RETREAT AT TIMBERRIDGE FILING NO. 3

COUNTY OF EL PASO, STATE OF COLORADO

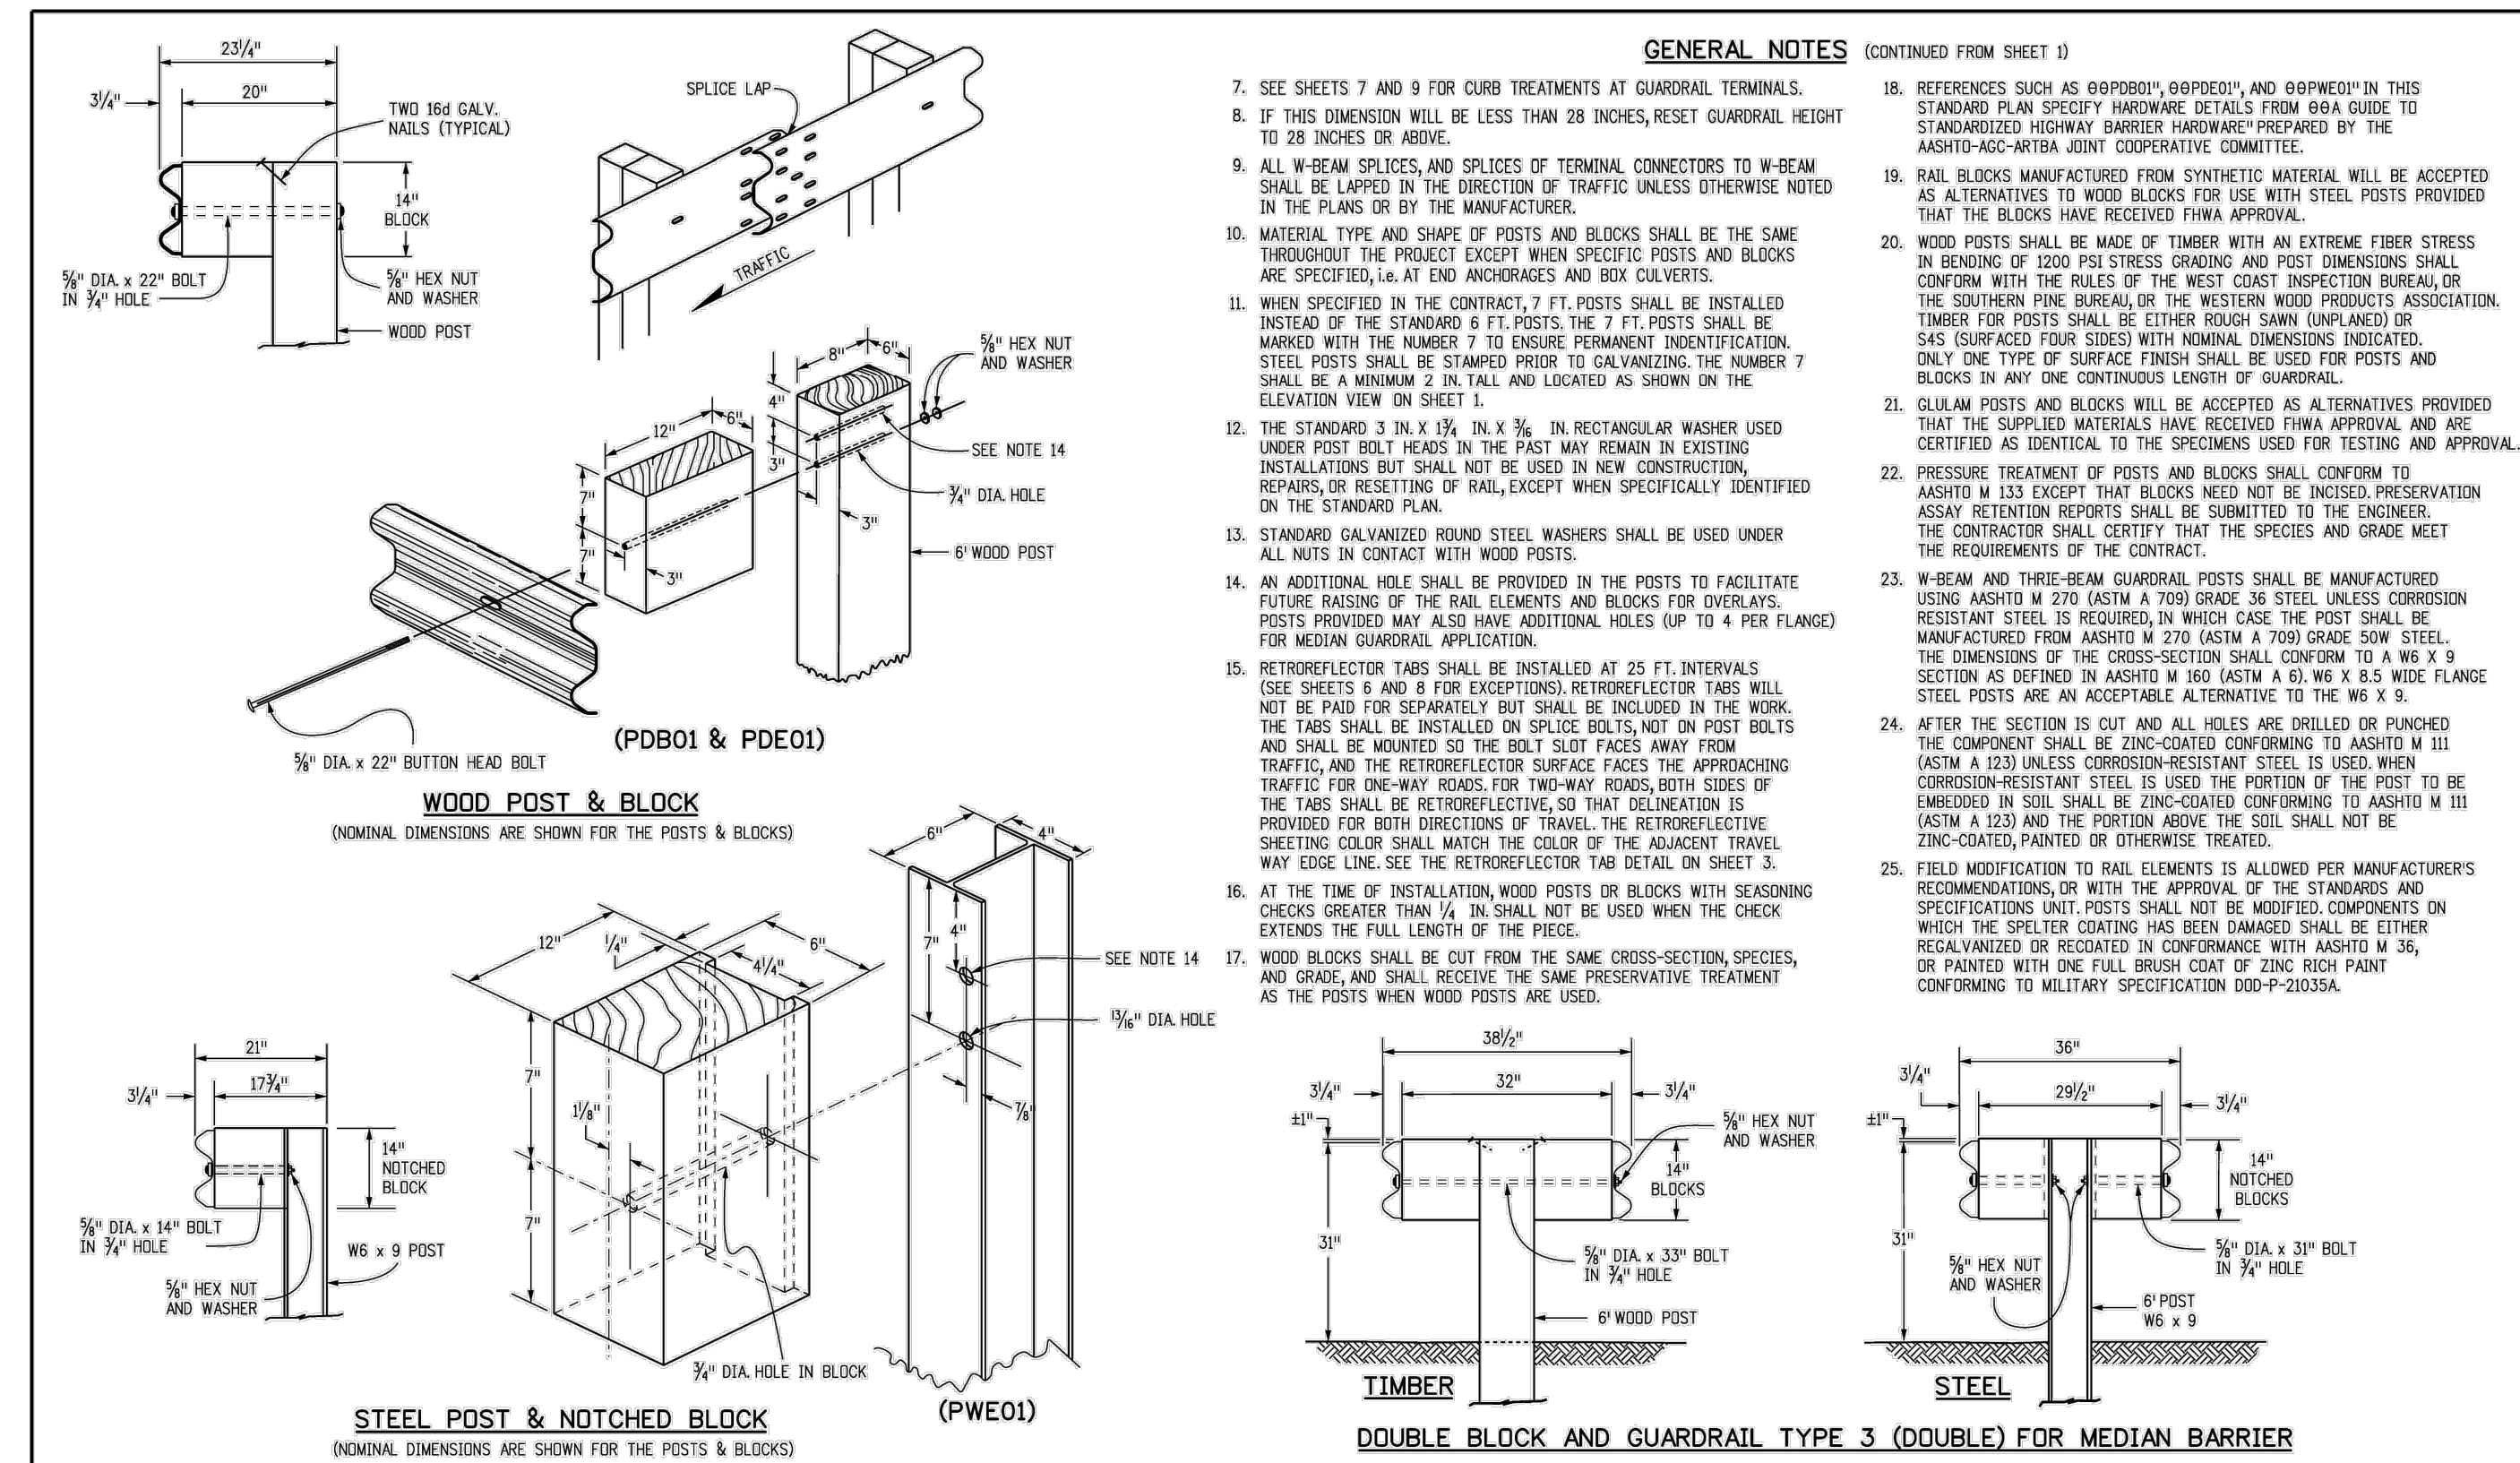
Computer File Information	Sheet Revisions	Colorado Department of Transportation	MIDWEST GUARDRAIL SYSTEM (MGS) TYPE 3 W-BEAM 31 INCHES	STANDARD PLAN NO. M-606-1
Creation Date: 07/31/19 Designer Initials: JBR Last Modification Date: 03/05/20 Detailer Initials: LTA CAD Ver.: MicroStation V8 Scale: Not to Scale Units: English	Date: 03/05/20 Comments: Revised per Note 1 to show MASH compliant	2829 West Howard Place CDOT HQ, 3rd Floor Denver, CO 80204 Phone: 303-757-9021 FAX: 303-757-9868	Issued by the Project Development Branch: July 31, 2019	Project Sheet Number:

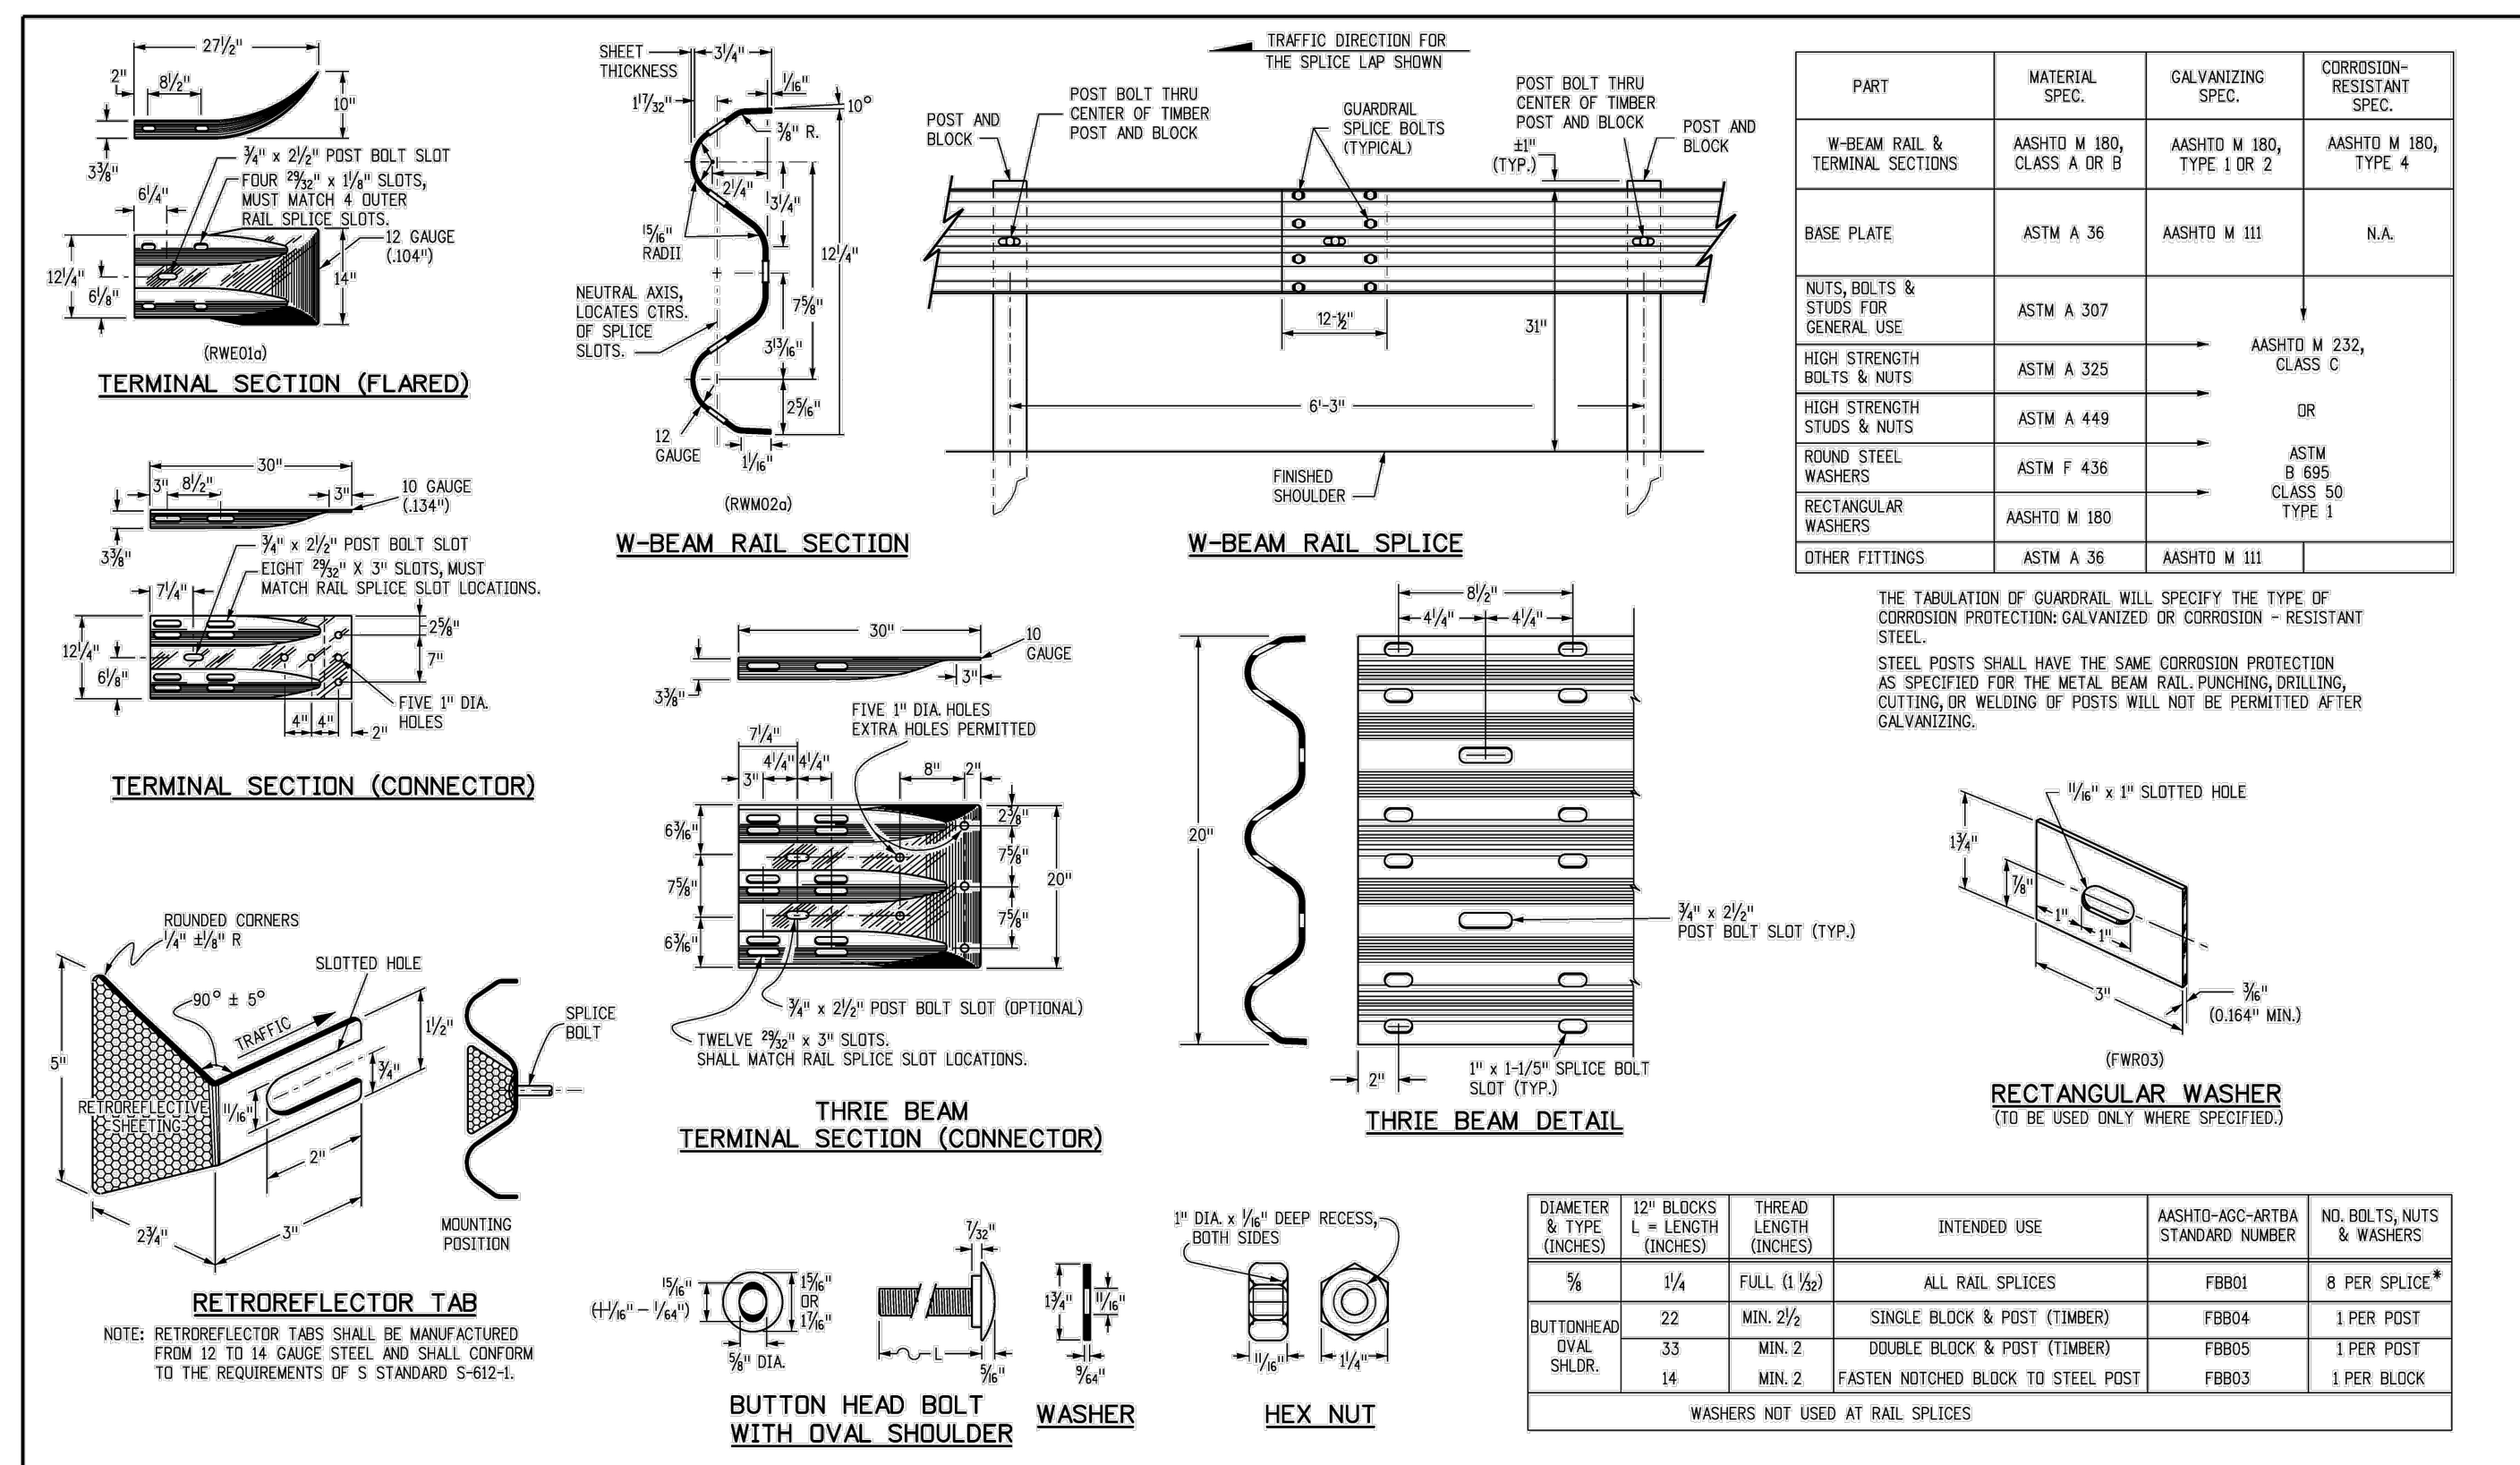
Computer File Information	Sheet Revisions	Colorado Department of Transportation	MIDWEST GUARDRAIL SYSTEM (MGS) TYPE 3 W-BEAM 31 INCHES	STANDARD PLAN NO. M-606-1
Creation Date: 07/31/19 Designer Initials: JBR Last Modification Date: 03/05/20 Detailer Initials: LTA CAD Ver.: MicroStation V8 Scale: Not to Scale Units: English	Date: 03/05/20 Comments: Revised per Note 1 to show MASH compliant	2829 West Howard Place CDOT HQ, 3rd Floor Denver, CO 80204 Phone: 303-757-9021 FAX: 303-757-9868	Issued by the Project Development Branch: July 31, 2019	Project Sheet Number:
